Reference: Film Studio Parking Demand and Traffic Generation Assessment

RE: REQUEST FOR FURTHER INFORMATION- RMA/2022/517, 129 WAIMAIRI ROAD, ILAM

Reference: RMA/2022/517 - Dovedale Digital Campus RFI Response

Status Stamp	WORKING PLOT
Date Stamp	
Scales	1:75 @ A1 1:150 @ A3
Drawing No.	310204072-01-001-C600-FIG 1
Rev.	A

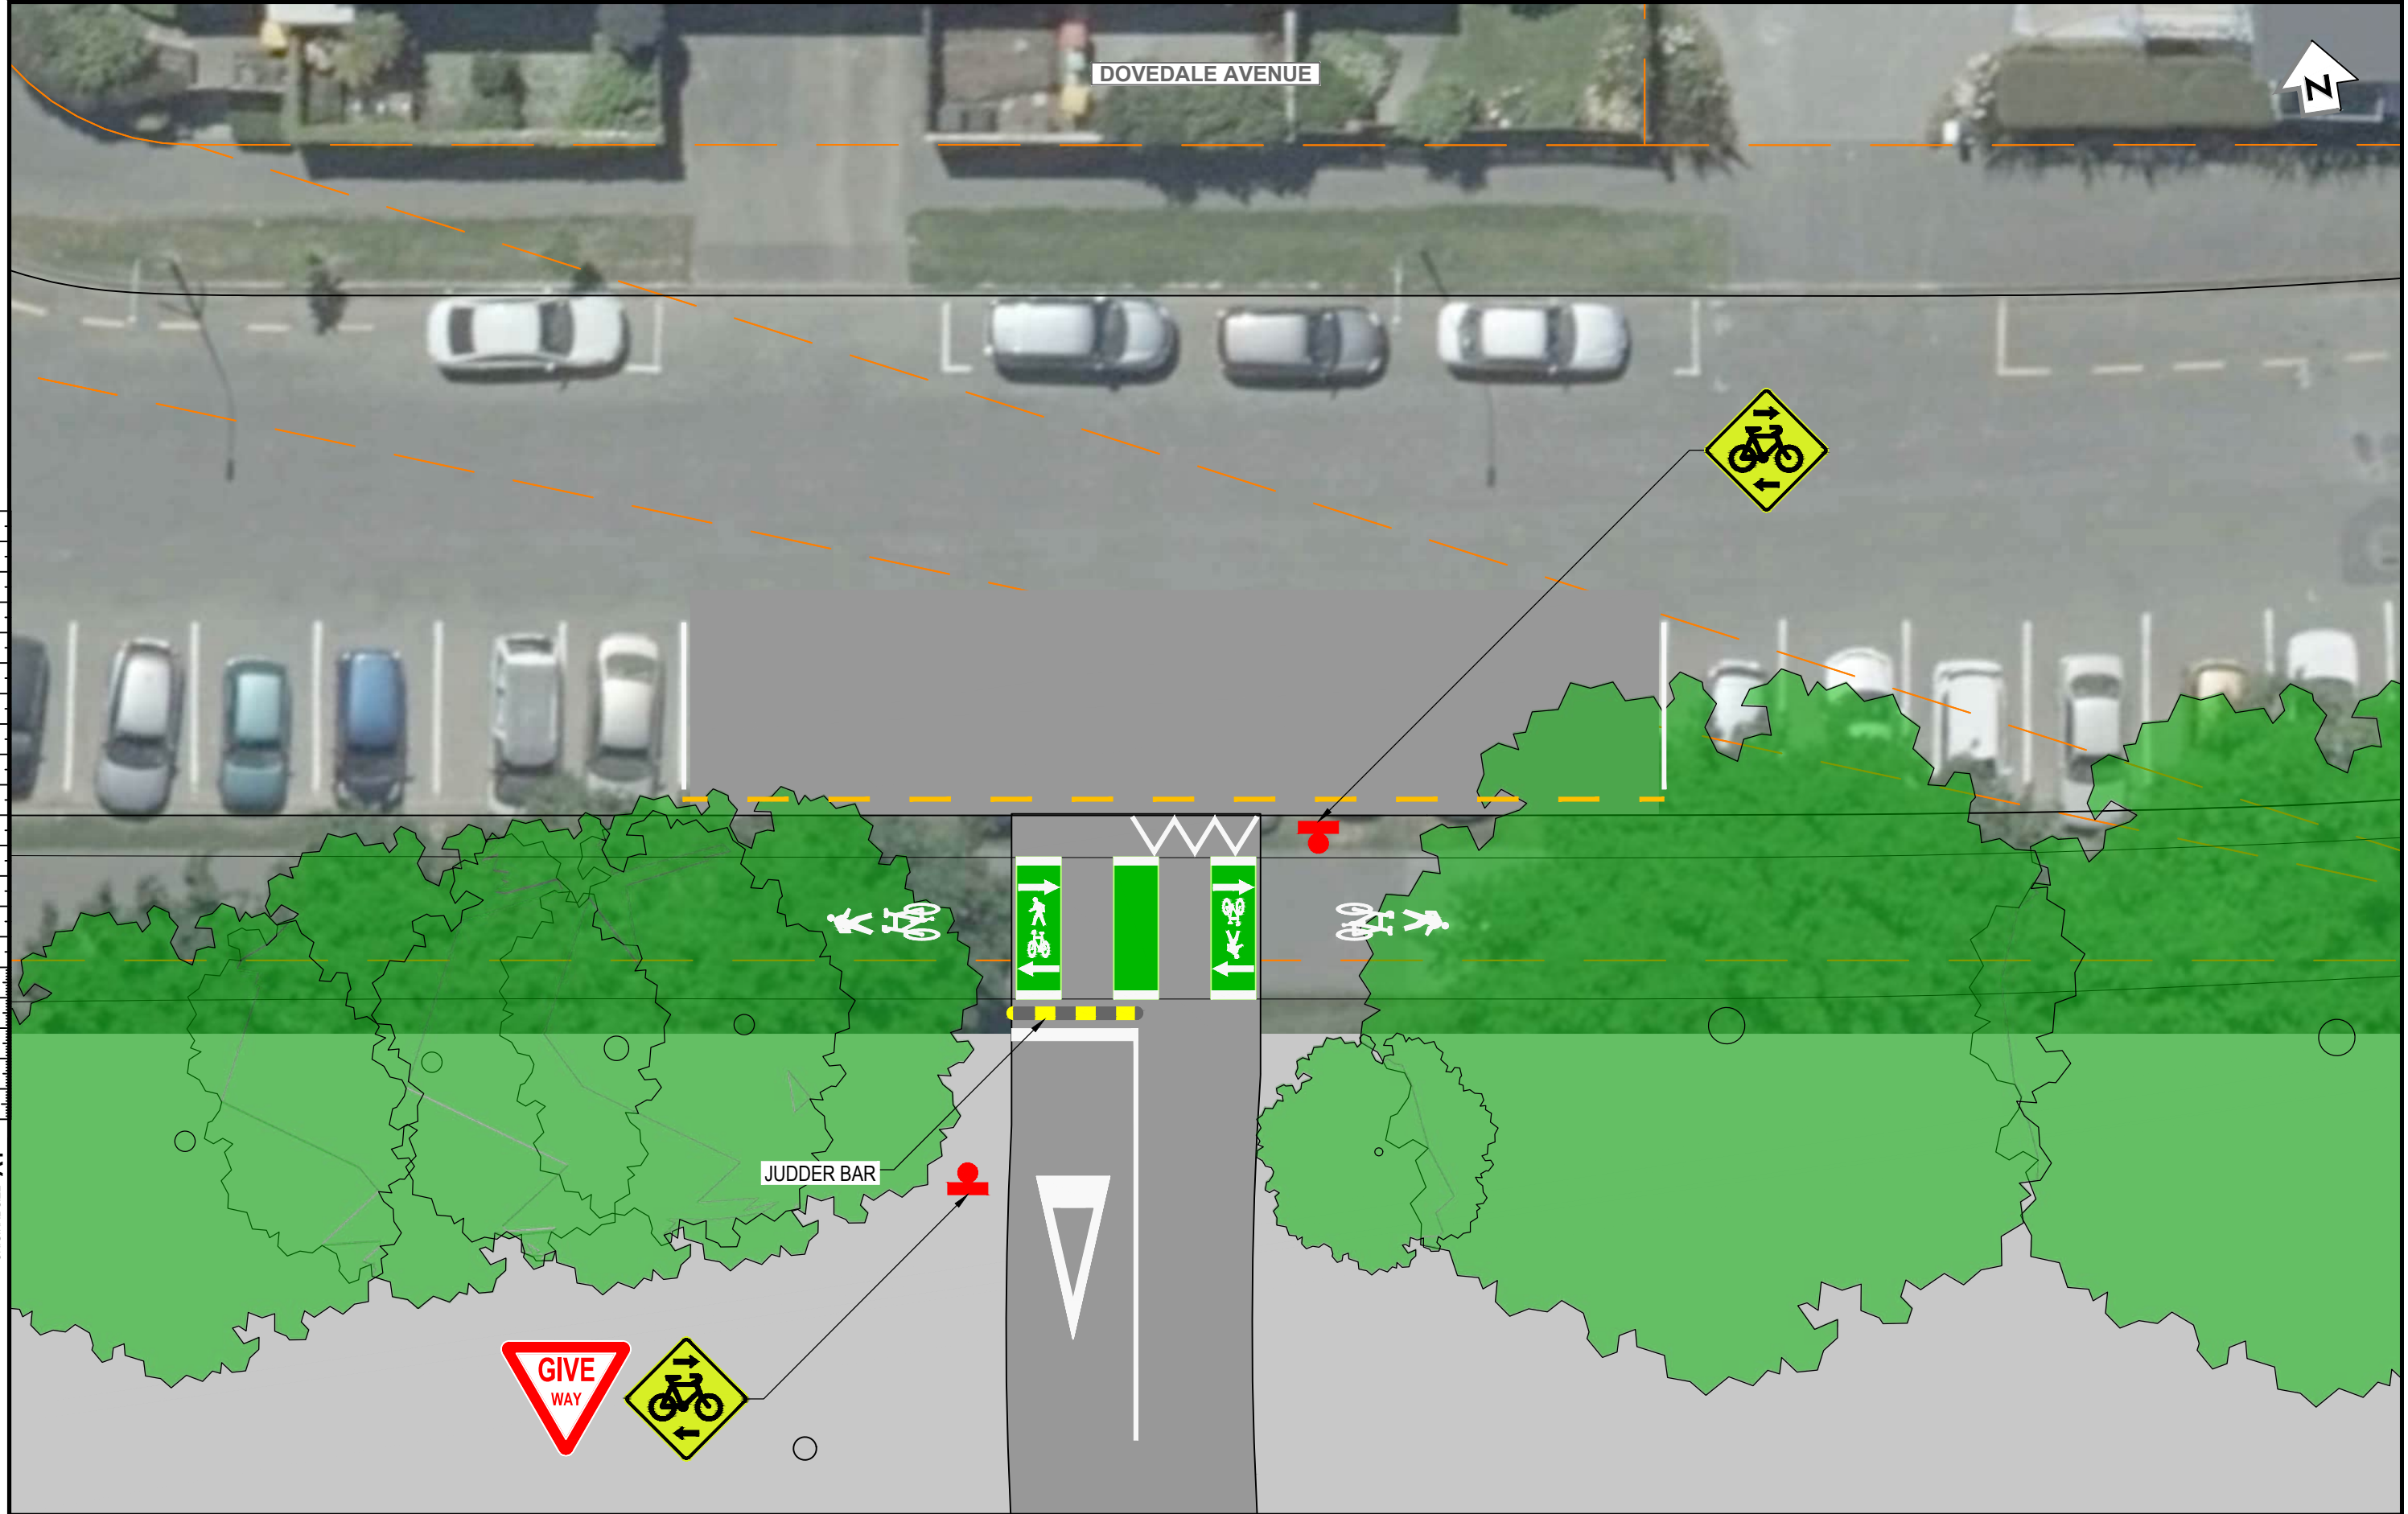
"That the new vehicle entrance way, shown in Figure 3 in the 220707 RFI Transport Response as access 2, is constructed in accordance with Design Plan 310204072-01-001-C600-FIG 1"

RFI 1c: The design of new Dovedale access to ensure safety of cyclists.

The general arrangement is shown in Figure 1 attached.

Status Stamp	WORKING PLOT
Date Stamp	
Scales	1:75 @ A1 1:150 @ A3
Drawing No.	310204072-01-001-C600 - FIG 2
Rev.	A

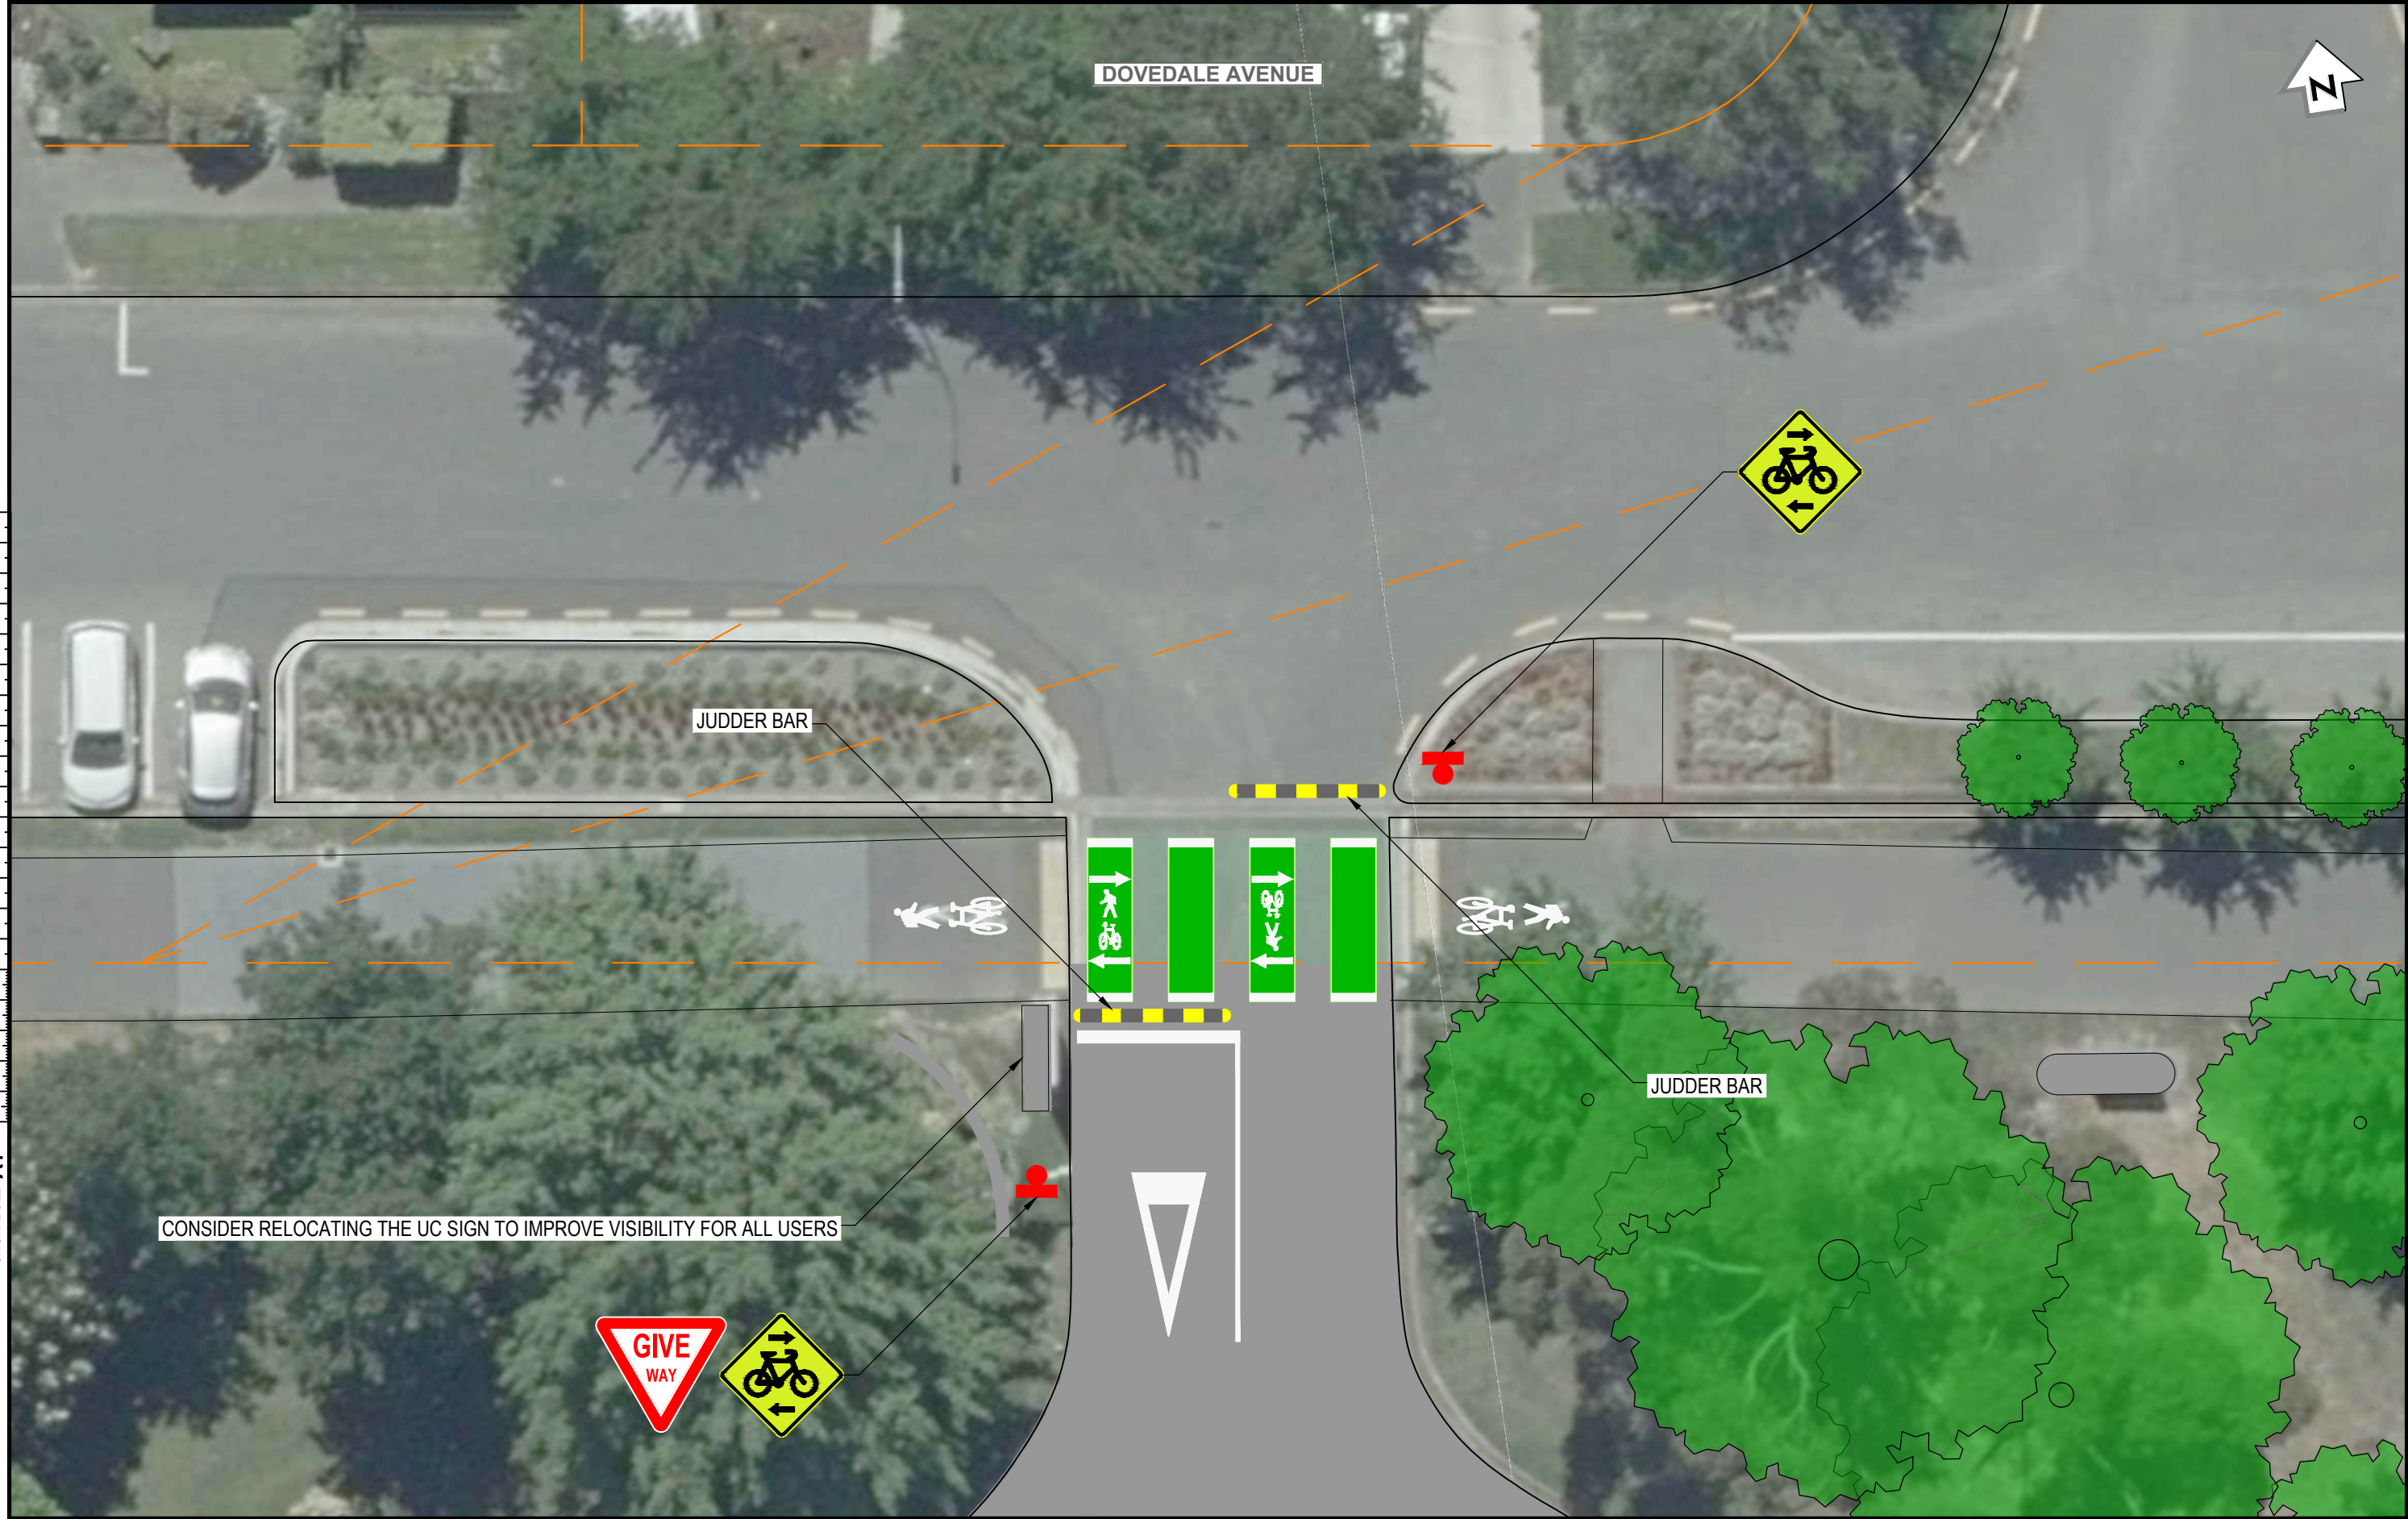
"That the existing vehicle entrance way, shown in Figure 3 in the 220707 RFI Transport Response as access 1, is re-designed in accordance with Design Plan 310204072-01-001-C600-FIG 2

This treatment could also be considered for implementation at the existing campus Ring Road access, which was designed at an early stage of the Major Cycleway rollout so had a basic marking treatment. The indicative arrangement that could be applied at the Ring Road vehicle crossing is included in Figure 2 attached.
